**TOWN OF LEESBURG
TOWN COUNCIL MEETING**

Subject: **TLAP-2013-0002** Appeal of the Board of Architectural Review decision in case TLHP-2012-0127 (Request to make exterior changes including adding a door and surround to the west side of 6 W. Market Street) (**Attachment 1**)

Staff Contact: Kim K. Del Rance, Preservation Planner

Figure 1. Elevation approved August 19, 2009

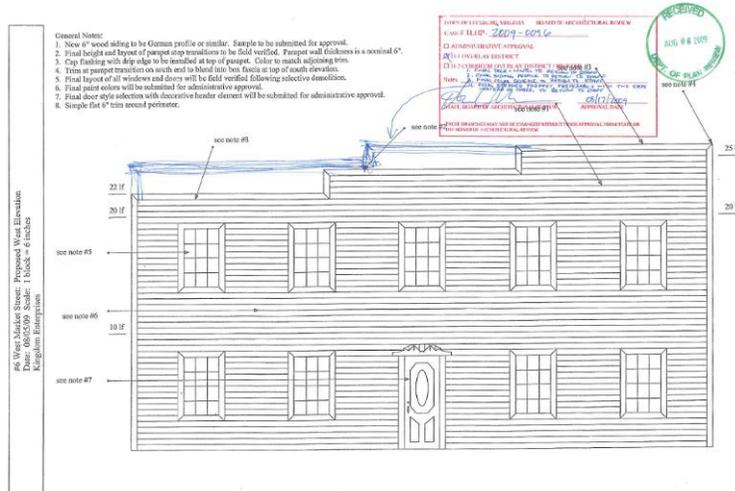
A Certificate of Appropriateness (COA) for TLHP-2009-0096 was approved with conditions for exterior changes on the west side of the building at 6 W. Market Street, but the door and lintel surround were to return to staff for final approval regarding materials and details. (see **Figure 1** below and **Attachment 3**)

Figure 2 Elevation approved June 4, 2012

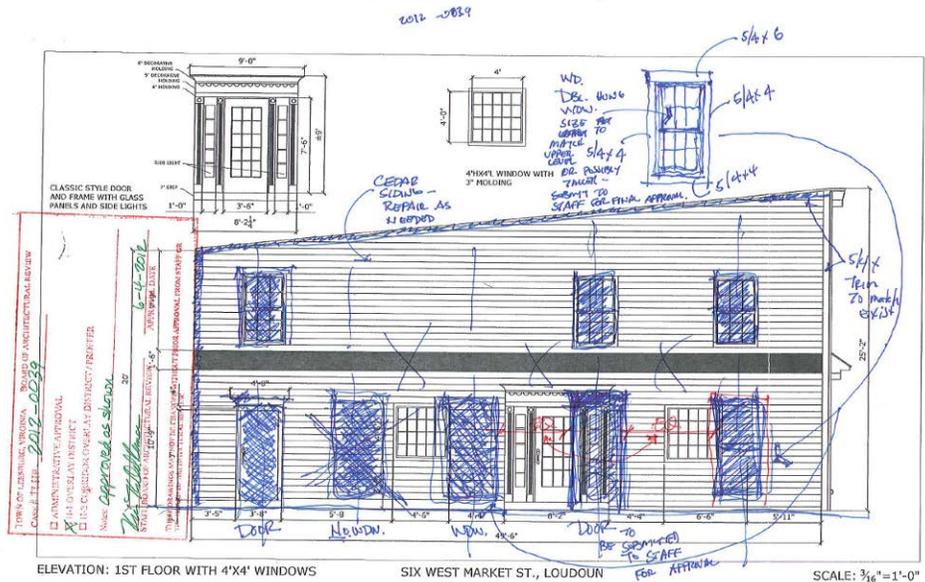
Michael J. O'Connor submitted an application to amend the previous COA regarding exterior changes on the west side of the building at 6 W. Market Street. The new COA designated TLHP-2012-0039 included a door and door surround with a lintel and sidelights as shown in **Figure 2** below.

“New decorative entry door to be submitted to staff for administrative approval” as shown on the sketch that was modified during the meeting (see **Figure 2 and attachment 8**).

Figure 5. Elevation 4 submitted by Mr. O'Connor

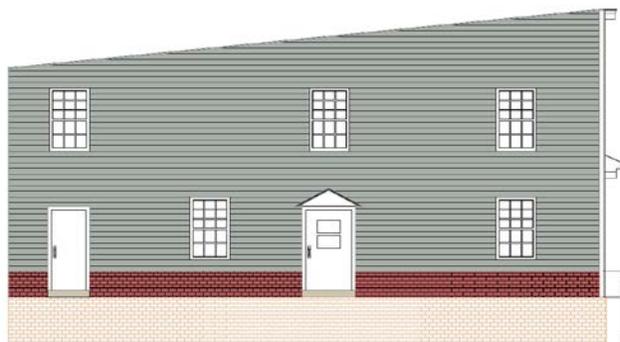
Board Member Teresa Minchew drew attention to the door surround on the drawing Mr. O'Connor had initially submitted for TLHP-2013-0127 which had no pilasters, columns, or sidelights and was much smaller than what had been installed. Ms. Del Rance stated that doorway was the proper scale.(see **Figure 5**)

Ms. Minchew asked Mr. O'Connor if he was willing to go back to what he agreed to. Mr. O'Connor replied he "never agreed to that". Mr. O'Connor asked "what difference does it make if we do suggest that this be the front of the building?" Mr. O'Connor expressed

Figure 8. Elevation 4

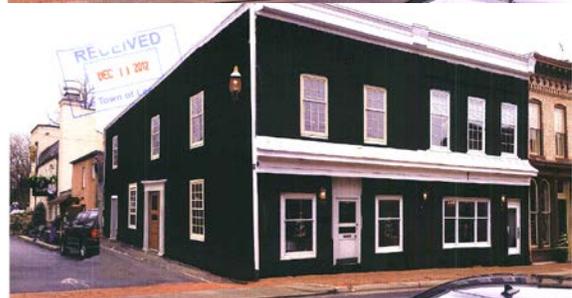
Ms. Minchew stated that this building was a contributing resource to the historic district and therefore requires a higher level of attention to added elements. She said while the door surround is beautiful it would be a crime to tear apart the current door surround; however, the door surround as shown in Elevation 4 is more appropriate.

Ms. Coffing suggested that a motion would be made to approve a new surround and to remove the current surround. Ms. Minchew confirmed with Mr. O'Connor that the elevations submitted depict the capitals being removed from Elevation 4 because the elevation was not clear enough to discern.

Several Board members stated the finished look of the side elevation of the building should match the Elevation 4 (as shown without the capitals) that Mr. O'Connor supplied on December 11, 2012 (**Figure 8** and **Attachment 20**) as an alternate view.

The BAR approved a Certificate of Appropriateness (COA) for the door surround as depicted in Elevation 4 (**Figure 8**.) submitted by the applicant by a vote of 4-3, with Koochagian, Kiley, Sisley and Meyer in favor and Minchew, Reimers and Coffing opposed. (**Minutes Attachment 23**)

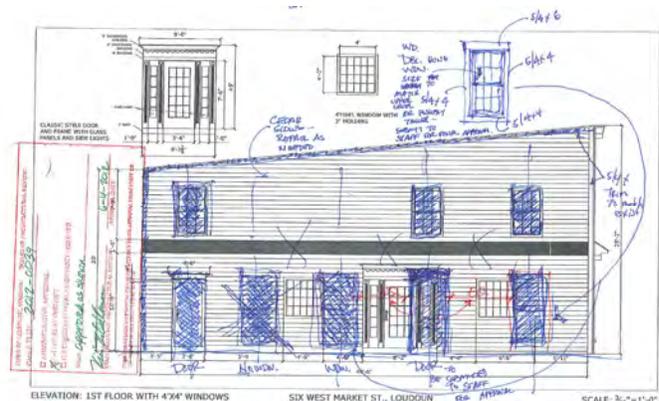
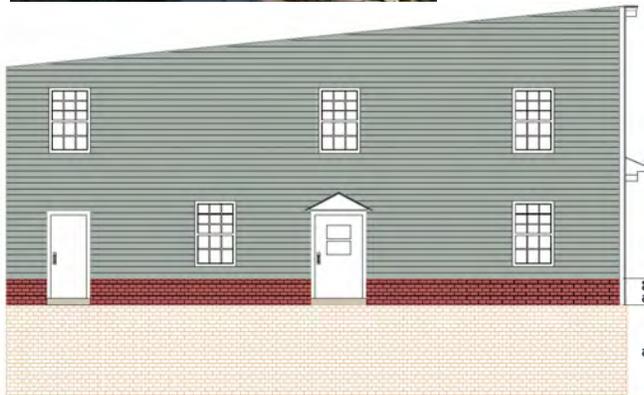
- (1) The owner has installed a Greek Revival door surround with pilasters with Corinthian capitals and a large pediment above a side entry door. The previous approved certificates of appropriateness, TLHP-2009-0096 granted in 2009 and TLHP-2012-0039 granted earlier this year showed a much simpler entry door and added windows all the same size to make the elevation more symmetrical and balanced.
- (2) The owner has installed lighting fixtures on the front elevation without approval
- (3) The owner requests to add brick to the lower edge of the side elevation and a brick sidewalk and to paint the building black with a gold painted trim, samples are in staff's office and will be brought to the meeting

- (1) The COA granted in 2012 stated that the door, surround and trim was to be approved by staff as the owner was looking for a salvaged door and did not have an example to be approved at that time. The owner installed the present door and staff approved it in place as appropriate, however, staff advised the owner that the surround should be simple, small enough to only cover the door and have no sidelights as this was a side entry and not to change the orientation of the building as is stated below in the guidelines:

1. The large light fixture be replaced with a smaller version of the same fixture
2. The door surround is removed and the pediment is replaced with a smaller pediment that is only above the door as is shown in the applicant's most recent drawing and siding is to be patched where it was removed for this door surround
3. The lower edge of the side elevation may have the bottom two rows of wood siding replaced with a closely matching fiber cement siding painted to match the existing siding
4. A dark traditional color, such as green, brown or blue is chosen for the main body of the building that is compatible with the brick
5. A contrasting traditional trim color is chosen that is compatible with both the new main body color and the existing brick
